Model: Russian-P2		Date: 30-Jan-01	No.: RG062001
Subject: Engine Firmware History		Prepared by: S. Tomoe	
From: Technical Services Dept., GTS Division			
Classification:	<input type="checkbox"/> Troubleshooting	<input type="checkbox"/> Part information	<input type="checkbox"/> Action required
	<input type="checkbox"/> Mechanical	<input type="checkbox"/> Electrical	<input type="checkbox"/> Service manual revision
	<input type="checkbox"/> Paper path	<input type="checkbox"/> Transmit/receive	<input type="checkbox"/> Retrofit information
	<input checked="" type="checkbox"/> Other ()

Model: Russian-P2		Date: 1-Jun-04	No.: RG062007
Subject: Non-paper feed jam (Bad friction pad)		Prepared by: S.Tomoe	
From: 1st Tech. Support Sec. Service Support Dept.			
Classification:	<input checked="" type="checkbox"/> Troubleshooting	<input type="checkbox"/> Part information	<input type="checkbox"/> Action required
	<input type="checkbox"/> Mechanical	<input type="checkbox"/> Electrical	<input type="checkbox"/> Service manual revision
	<input type="checkbox"/> Paper path	<input type="checkbox"/> Transmit/receive	<input type="checkbox"/> Retrofit information
	<input type="checkbox"/> Other ()

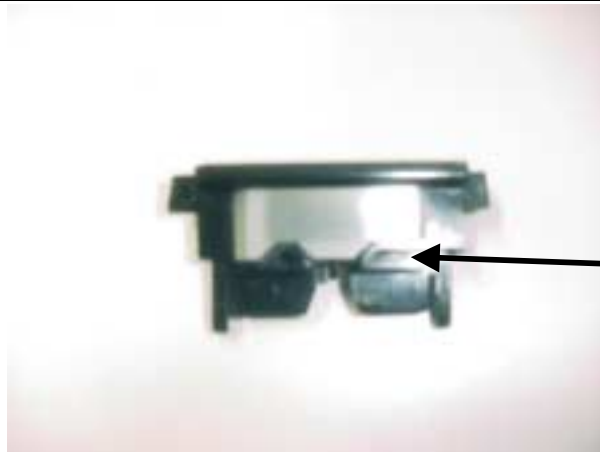
A defect in one of the molds that the manufacturer uses to produce the friction pad left a burr on the pad surface, catching the paper and preventing it from being fed.

Note: Only one of the two molds used to form the friction pad was defective (Cav 2).

Cav number (1 or 2) is visible here.
 Cav 1: Normal
Cav 2: May be defective

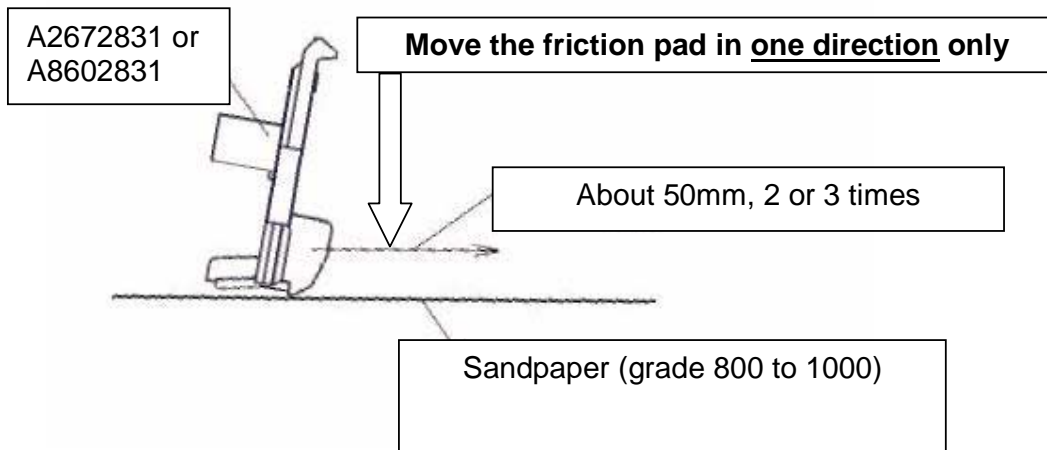
2. If it is suspected that the non-feed is caused by a defective friction pad, please try the following:

- (1) Replace the friction pad

- (2) Remove the burr with grade 800 to 1000 sandpaper

Rub the friction pad along a 50mm length of the surface of the sandpaper as shown below, two or three times **in one direction only** (do not move the pad back and forth). This is essential to ensure that the paper is fed smoothly.
